ADDENDUM

03 | 250124

McCaskey High School Stadium Projects
Lancaster, PA

Marotta/Main Architects Project No.
24-SDL-03

SHEET NUMBER:
A3.1

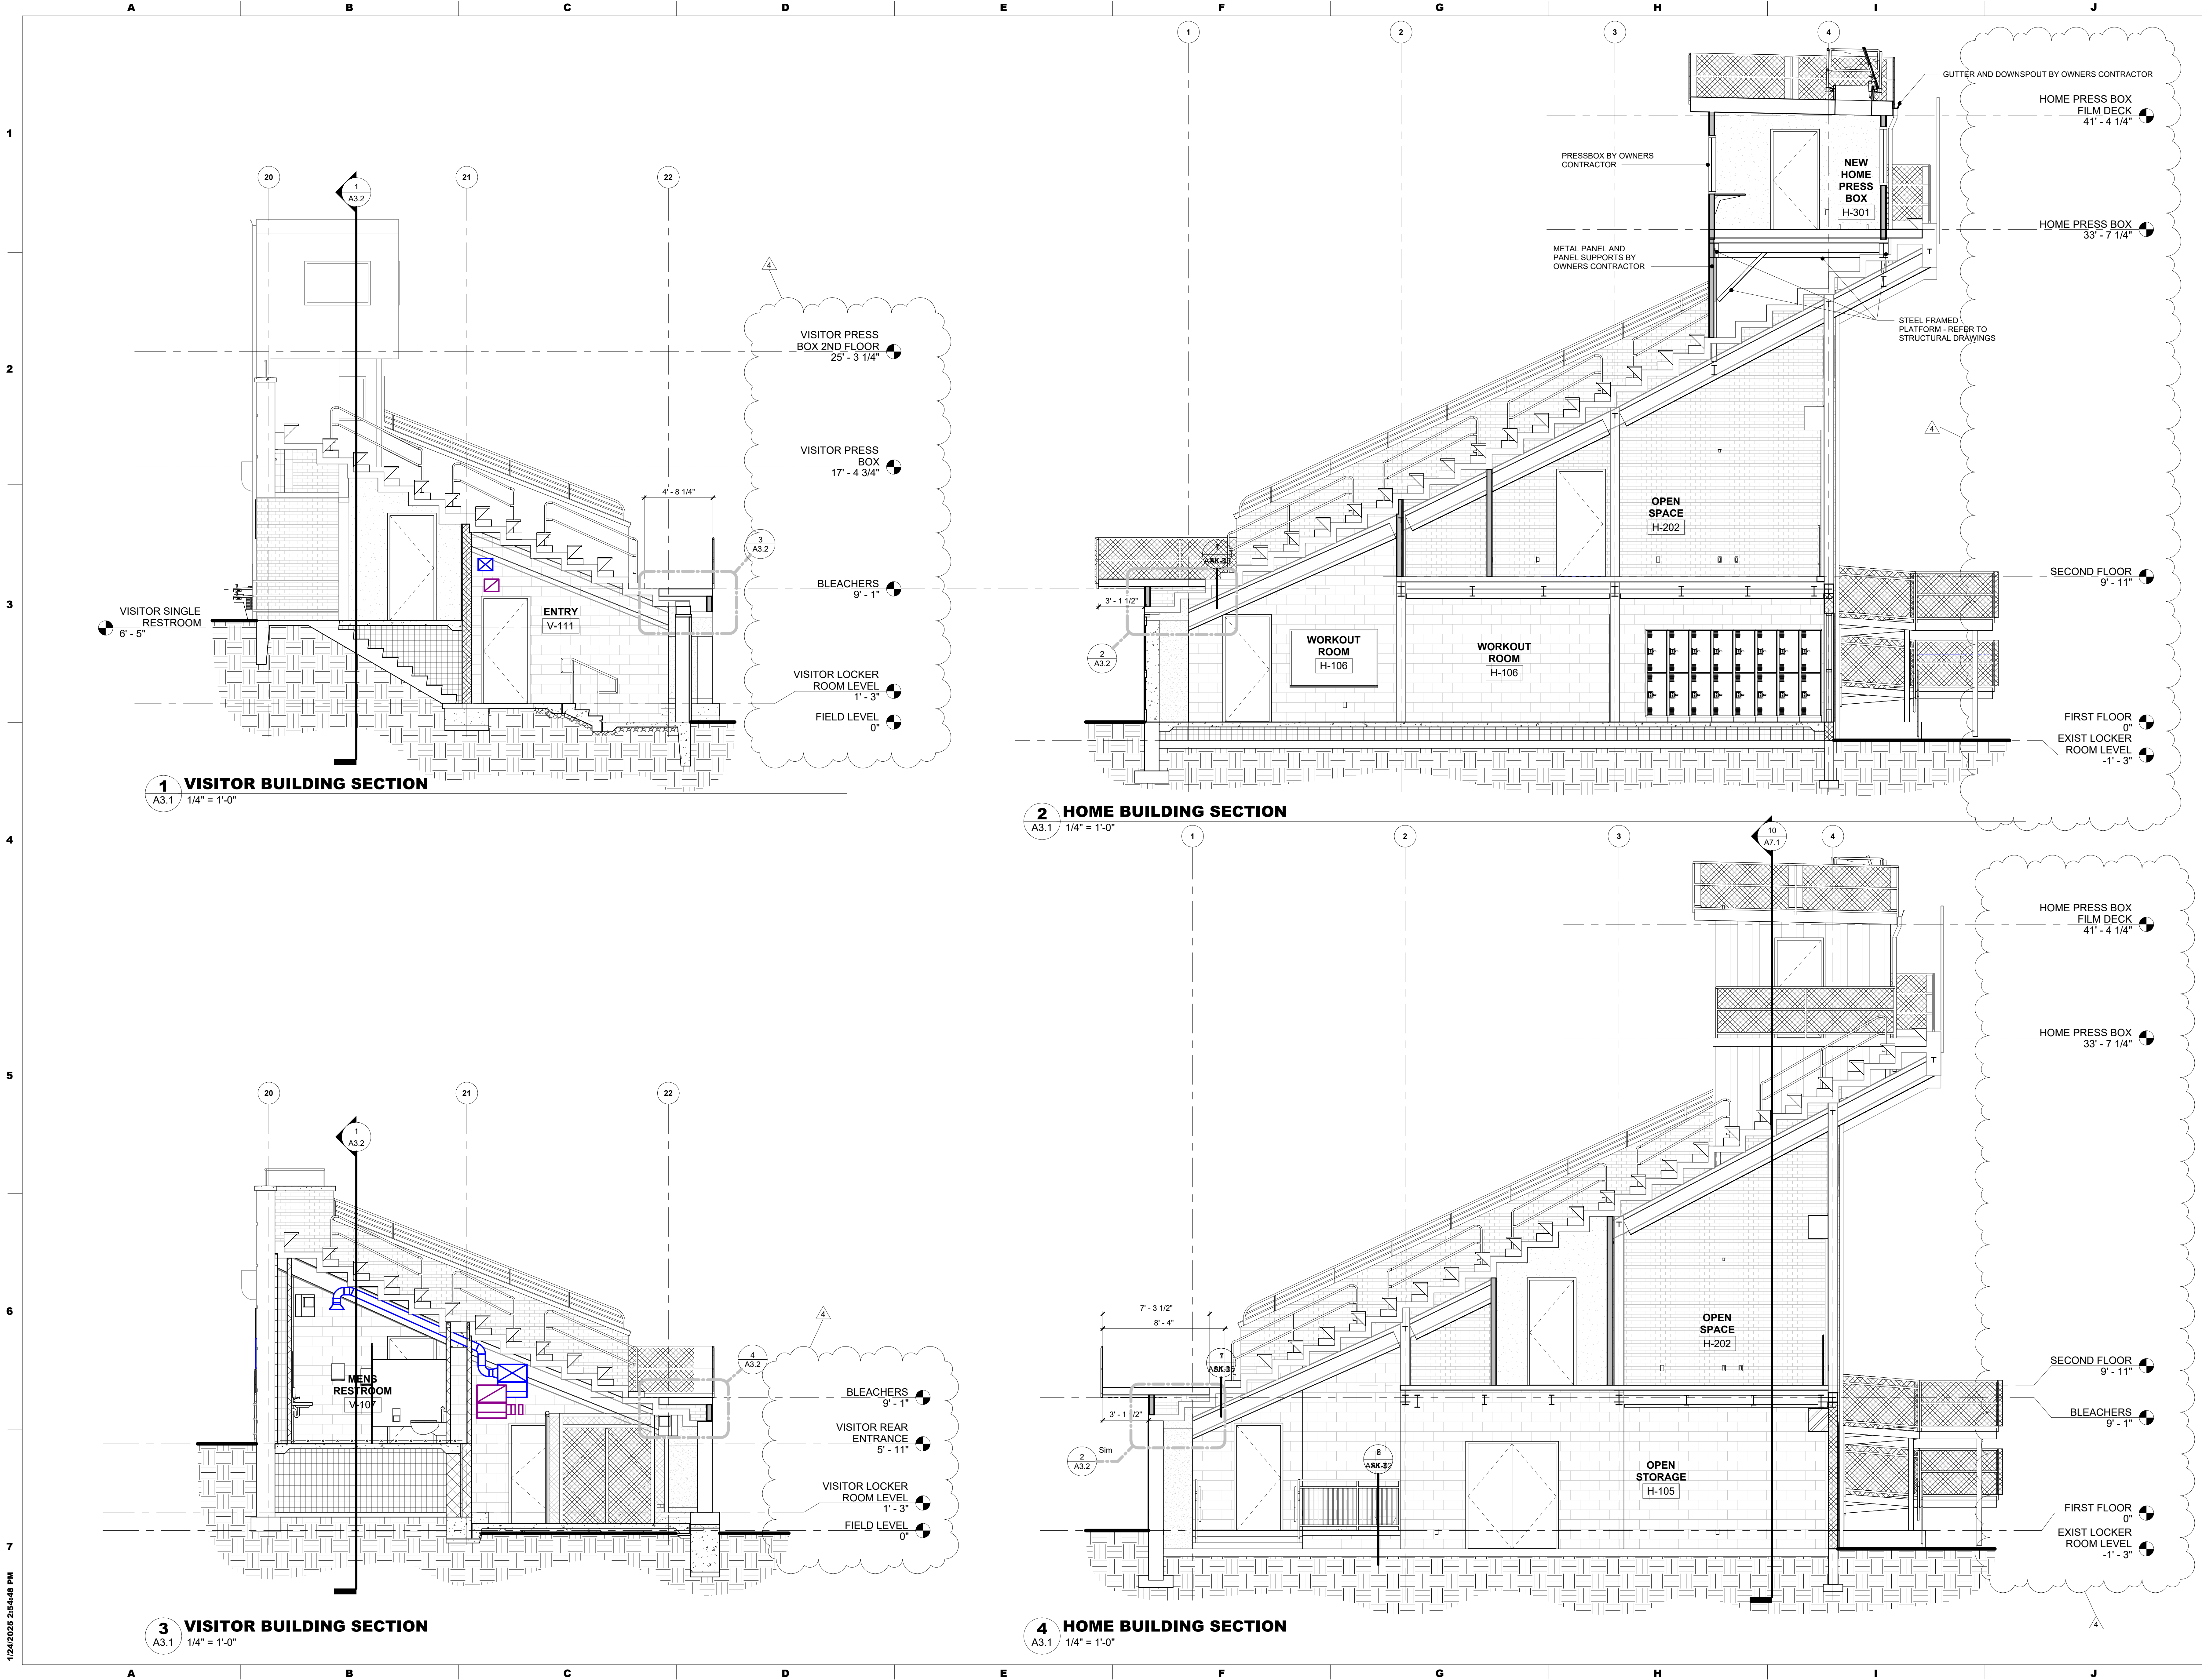
- 03.09 Refer to Drawing A3.1 BUILDING SECTIONS – REVISE elevations heights – Reissue sheet A3.1
- 03.10 Refer to Drawing A8.5 – ENLARGED PLANS & INTERIOR ELEVATIONS

1 ENLARGED RESTROOM PLAN
 ASK-04 1/2" = 1'-0"

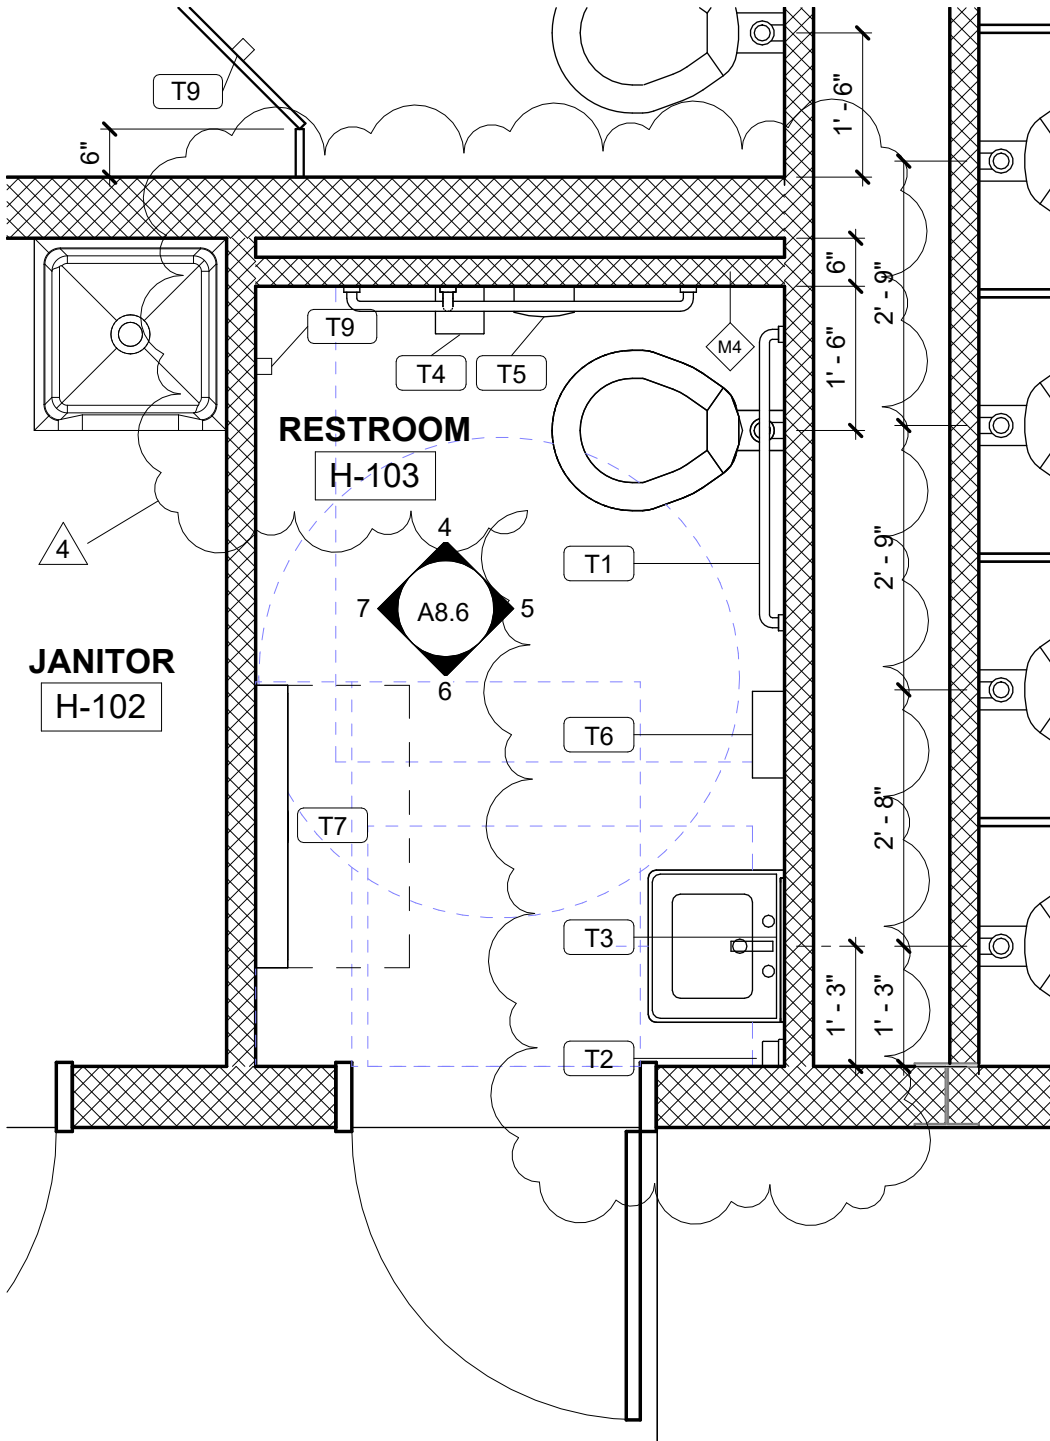
- a. REVISE location of the water closet and sink. - Refer to sketch ASK-04.
 - b. ADD P4 partition - Refer to sketch ASK-04.
- 03.11 Refer to Drawing A9.1 – DOORS & WINDOW SCHEDULE & TYPES
